FINAL ADDENDUM TO THE DRAFT EIR

MEDICAL INSURANCE EXCHANGE OF CALIFORNIA OFFICE BUILDING EXPANSION Environmental Impact Report

ER 89-42 SCH# 90030297

Prepared for:
City of Oakland
City Planning Department

Figure 21 (revised)
Existing Conditions,
PM Peak-Hour Traffic Volumes

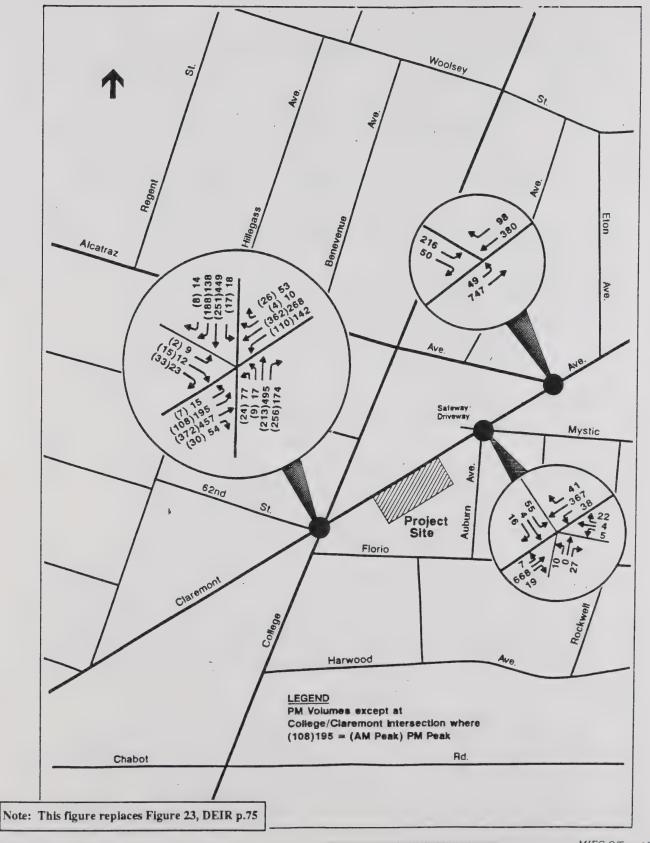
Page 64, Figure 21 is replaced by a revised Figure 21 (see pp. 10A and 41 of this document).

Figure 23 (revised)
Peak-Hour Traffic Volumes
at Key Intersections, Existing Plus Project

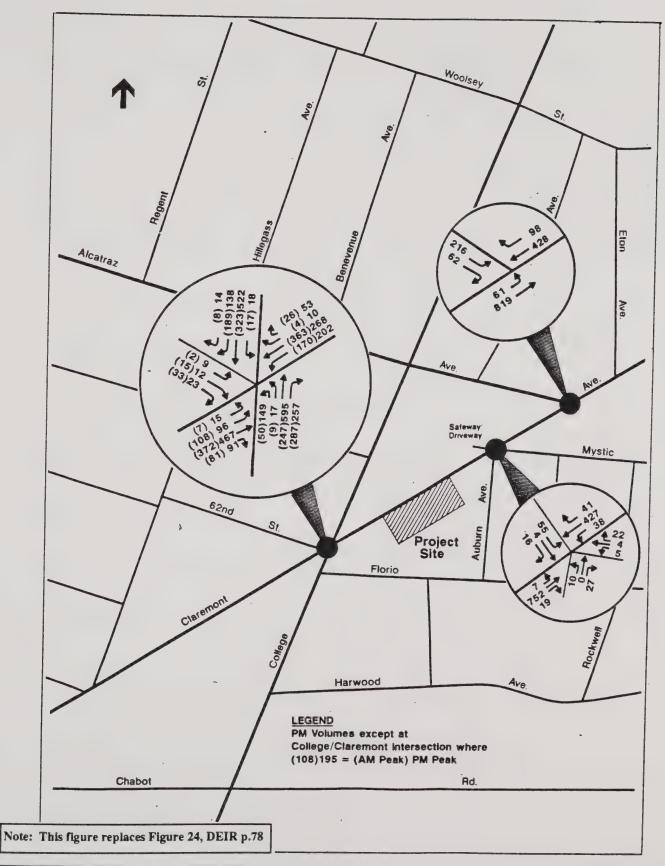
Page 75, Figure 23 is replaced by a revised Figure 23 (see pp. 10B and 42 of this document).

Figure 21 (revised)
Existing Conditions,
PM Peak-Hour Traffic Volumes

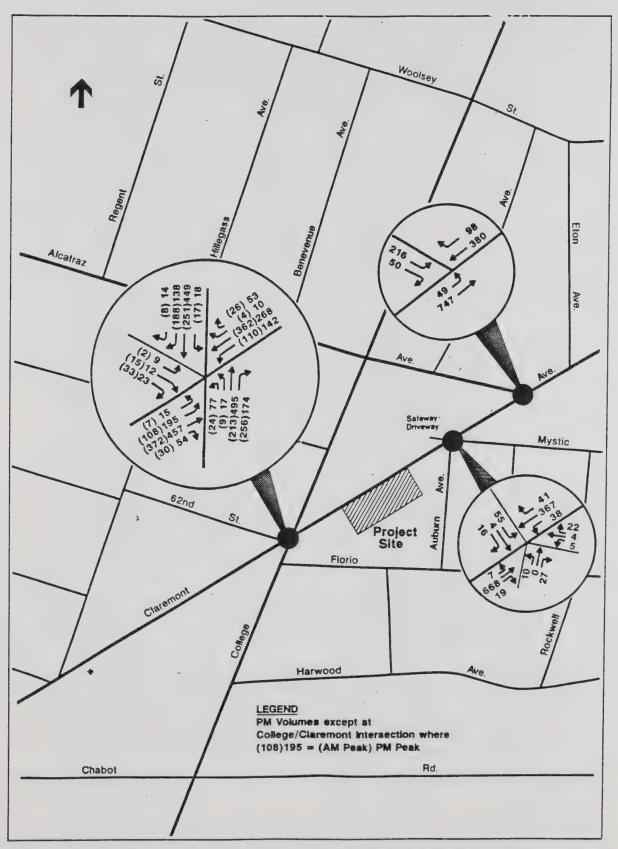
- 3) The traffic counts illustrated in Figure 21 for the intersection of Claremont and College Avenues are inaccurate because they omit a critical turning-count: the 62nd Street left-turn off of College.

- 9. Figure 21 is modified to include the volumes for 62nd Street left turns off of College Avenue (see Figure 21 (revised), attached). It should be noted that this turning movement is not "critical," by traffic engineering standards; i.e. addition of vehicle turns to this movement would not necessarily decrease the overall level of service of the intersection and would not change the overall conclusion of the analysis. Similar changes are made for the existing plus project and cumulative plus project conditions (Figures 23 (revised) and 24 (revised), respectively).
